# Appendix A

Biological Review (#95-200-104)

Environmental Assessment September 1995

BIOLOGICAL REVIEW OF THE SOLID WASTE RETRIEVAL COMPLEX, ENHANCED RADIOACTIVE AND MIXED WASTE STORAGE FACILITY, INFRASTRUCTURE UPGRADES, AND CENTRAL WASTE SUPPORT COMPLEX, 200 West Area, #95-200-104 (Amendment 1)

# ACREAGE CALCULATIONS FOR PROJECT W112 / W113

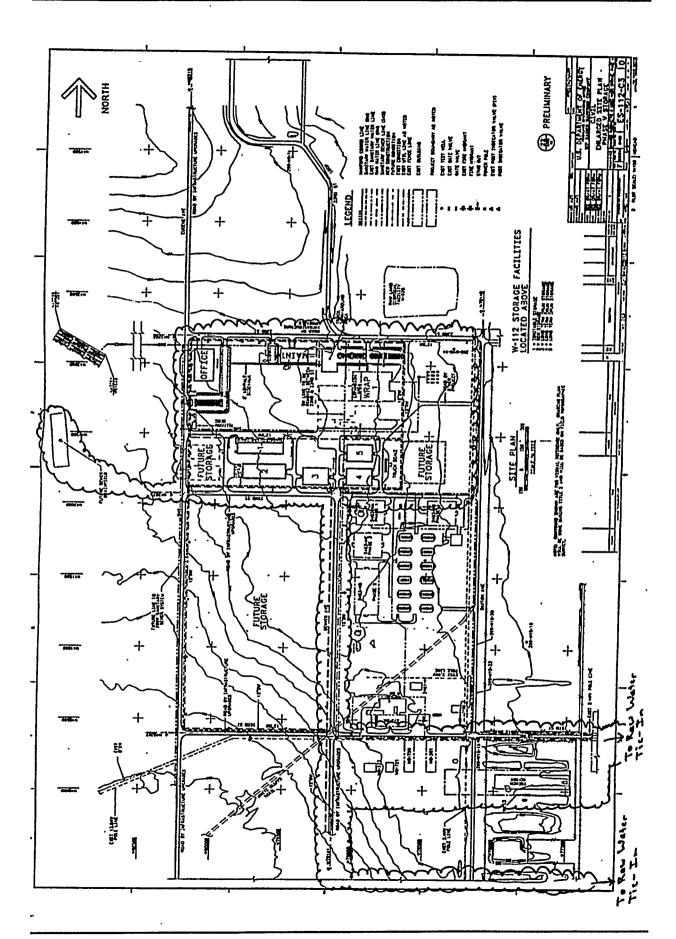
AREA		ACREAGE	
"Area 1" - Between Dayton and Denver, 22nd and WRAP 1 -		12 acres	(8 priority)
"Wrap 1 Area" - previously disturbed -		10 acres	(0 priority)
"Area 2" - between Denver and Eugene, 22nd and 23rd -		28 acres	(28 priority)
"Sewer Area" assume 800'x40' pipeline, 125'x400' drainfield -		2 acres	(2 priority)
Denver avenue from 22nd to 16th street (assume 1 mile long, 100'wide) -		12 acres	(12 priority)
16th street water line (assume 2000'x40') -		2 acres	(0 priority)
"4C-T04 Area" - assume 2000'x500' -		23 acres	(0 priority)
	TOTAL	89 acres	(50 priority)
